**RE: University of Sydney - Engineering and Technology Precinct
Mod 2 (SSD-8636-Mod-2)
Request for Additional Information**

This letter is to confirm Cox Architecture's support towards the current proposed design for the South, North and East plazas as part of the Engineering and Technology Precinct project at University of Sydney. Cox considers that it is an improvement to the design presented as part of the State Significant Development Application submission (Ref: SSD-8638).

Please refer to the supporting documentation as included in Appendix A.
The supporting documentation include comparison plans showing approved and proposed plazas and additional information about the Basin D replaced by a bioretention basin.
Moreover, It includes the changes to plant species and number of trees across the site.

Proposed plan - South Plaza

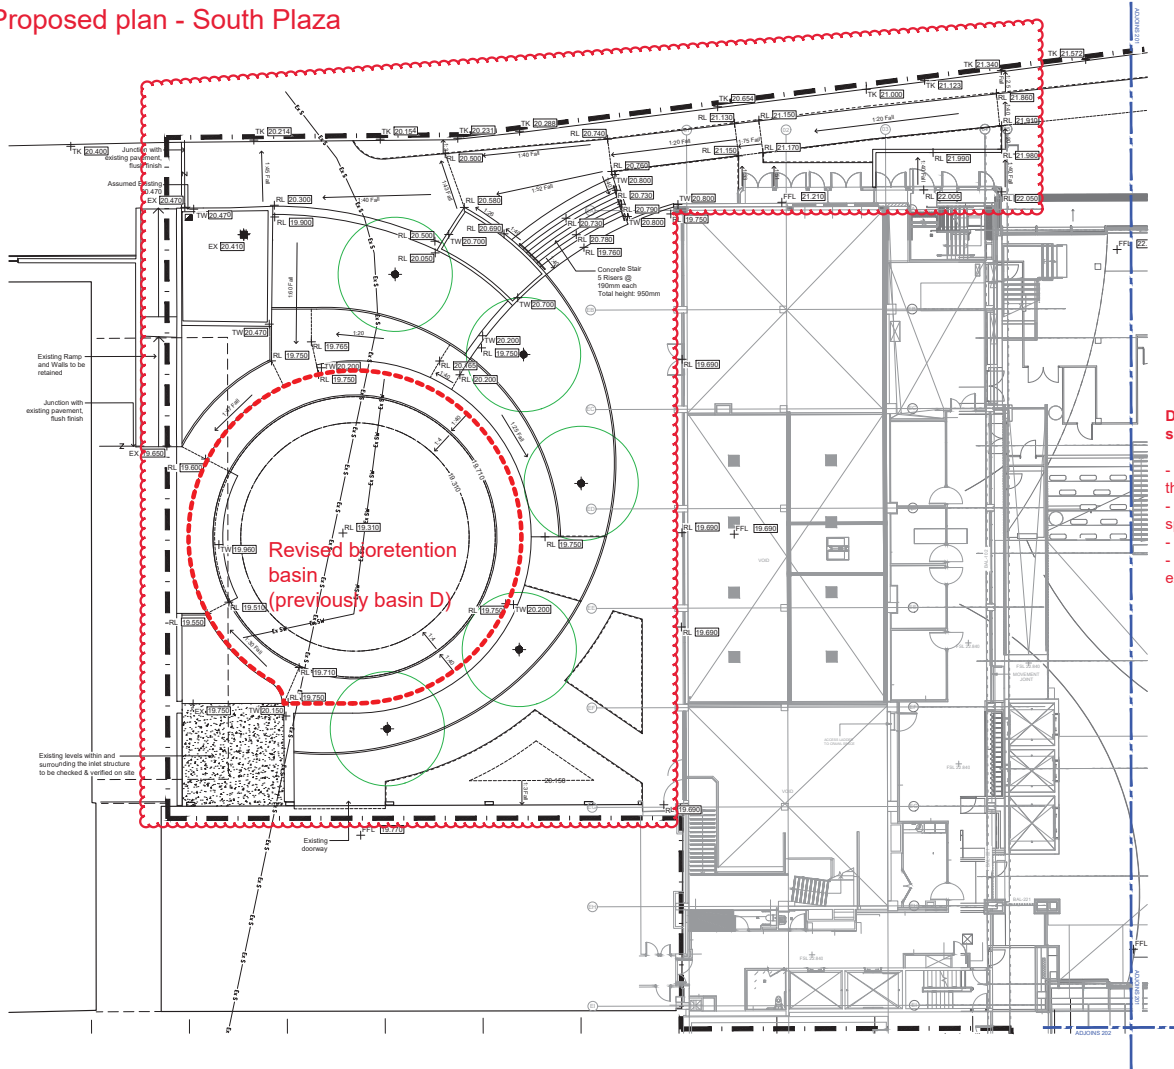
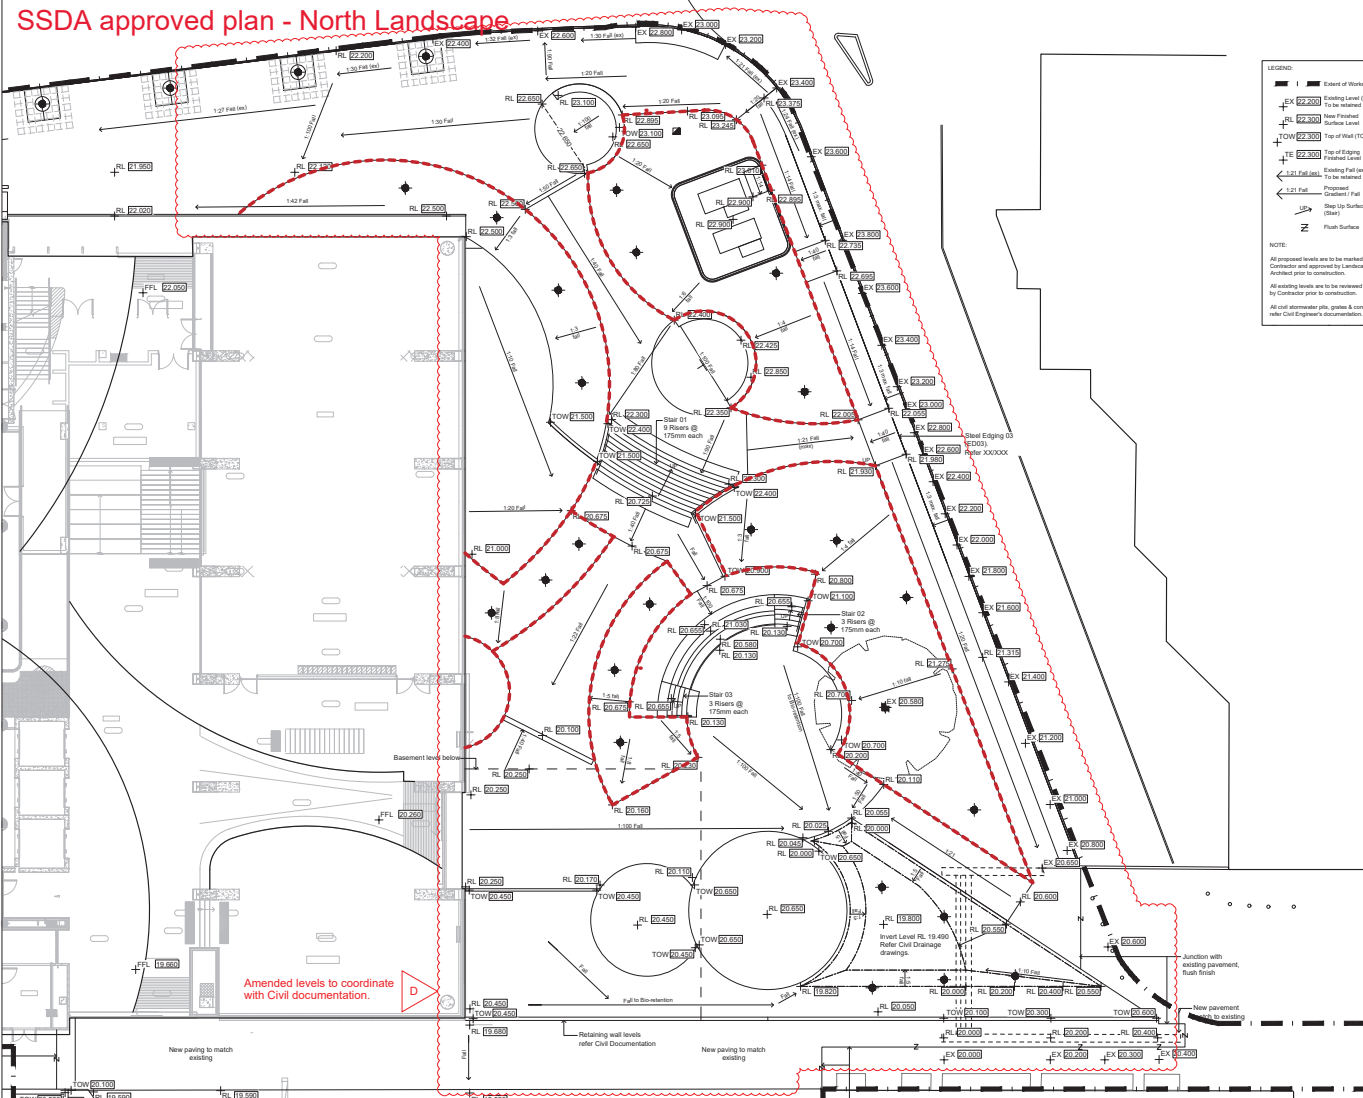
Revised bioretention basin
(previously basin D)

Design changes from SSDA scheme:

- Improved connection throughout the landscape
- Defined gathering and meeting spaces
- Porous ground plane
- Improved disabled access experience

Proposed plan - North Landscape

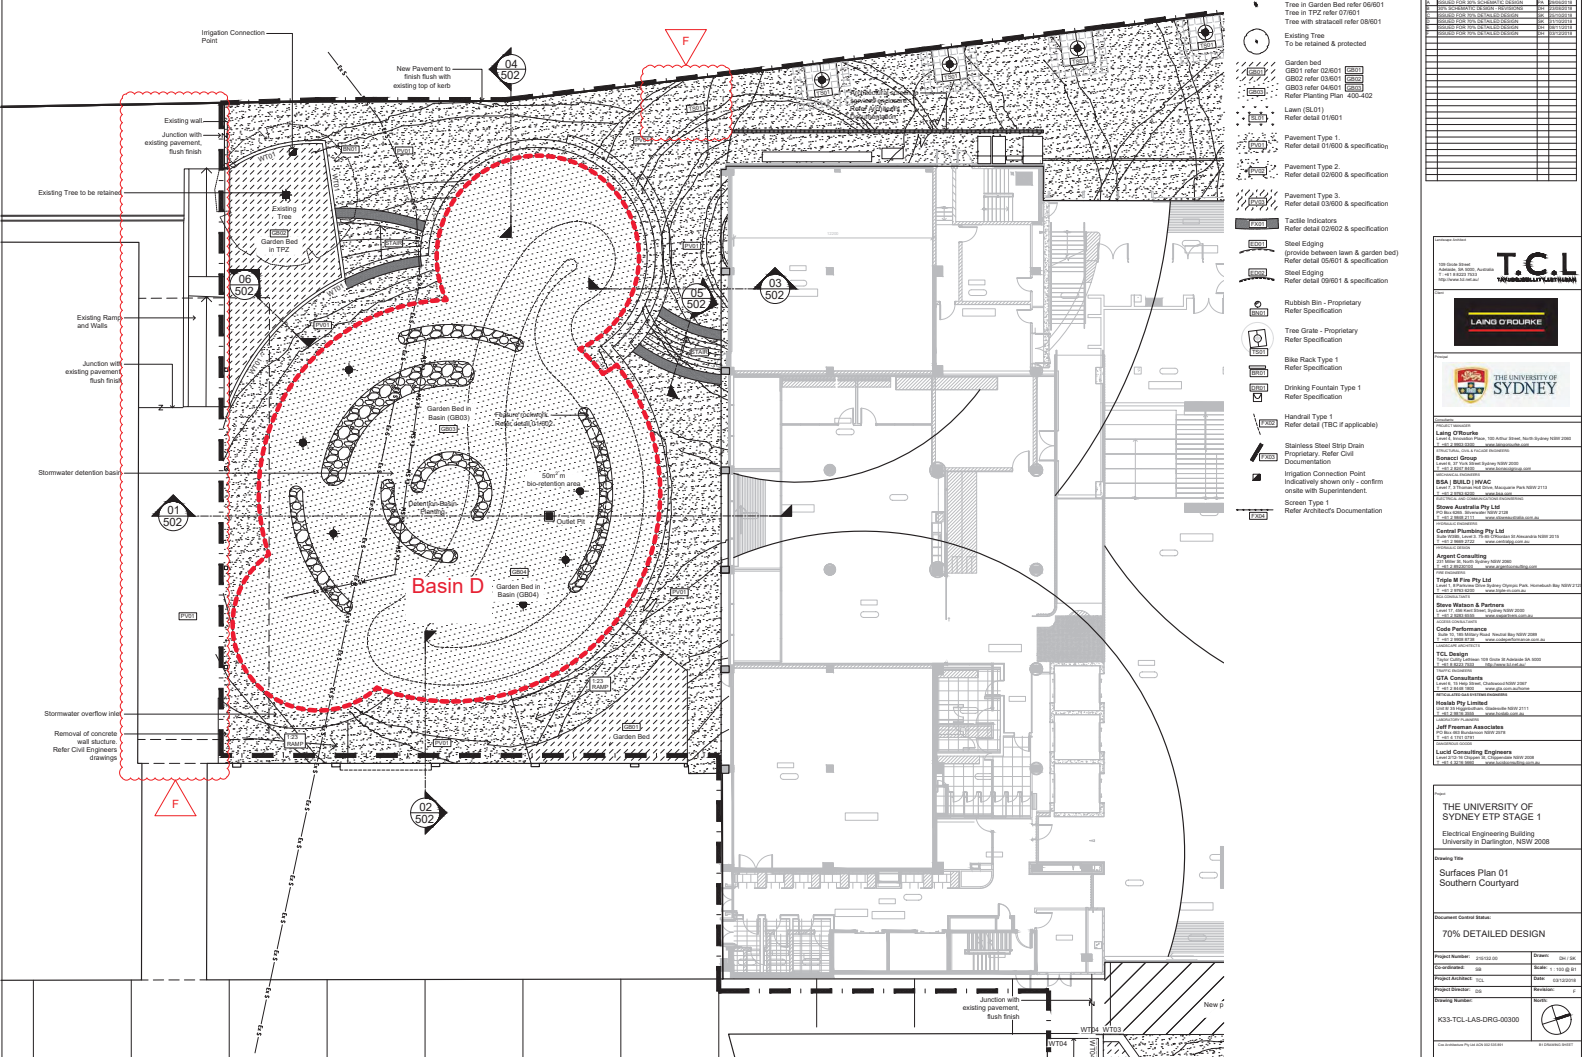
Design changes from SSD scheme:

- Improved way finding.
- 3 main spines
- Defined gathering and meeting spaces
- Increased green space, encouraging more planting & paving
- Simplified levels
- Improved disabled access experience

Proposed new plant - East Landscaping

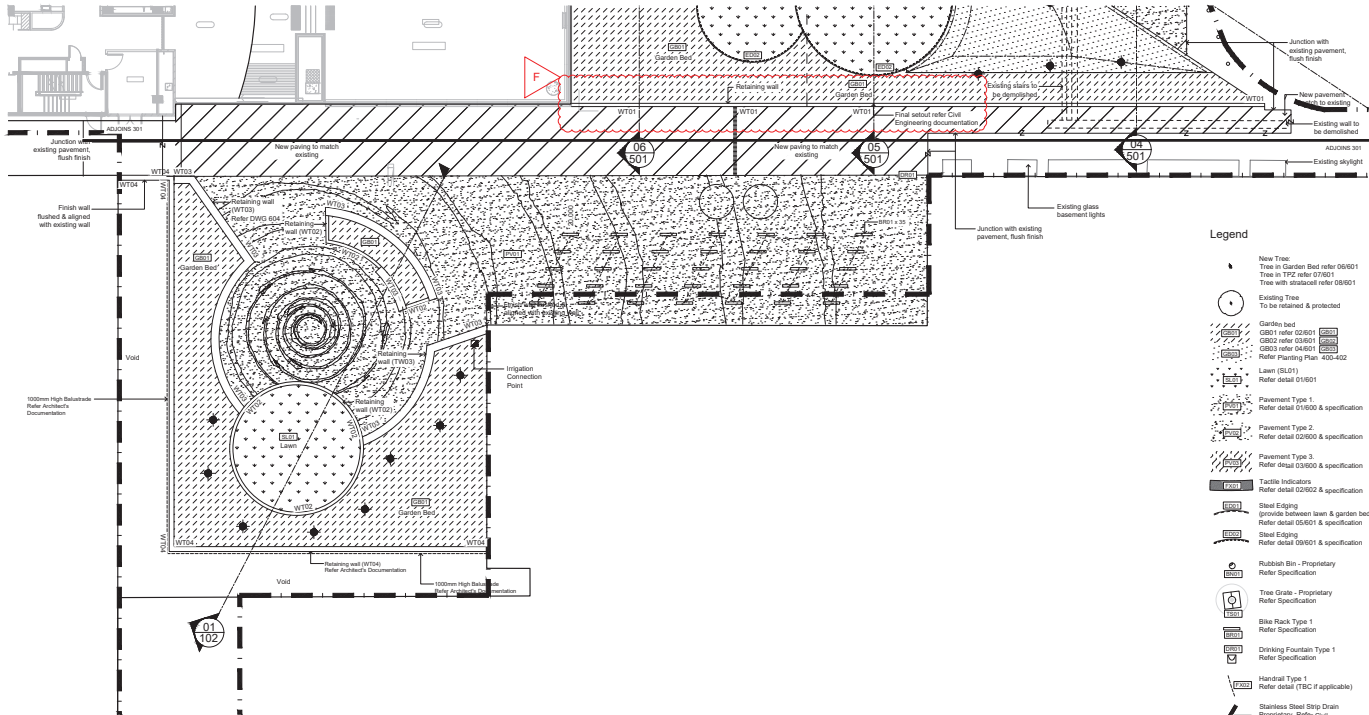
Engineering walk awning added to improve user access experience and provide weather protection to building entry and associated bike racks.

Engineering walk awning added to improve user access experience and provide weather protection to building entry and associated bike racks.
For details please refer to the following to drawings sheets
K33-COX-ARC-DRG-16-20 Rev 2
K33-COX-ARC-DRG-16-21 Rev 2
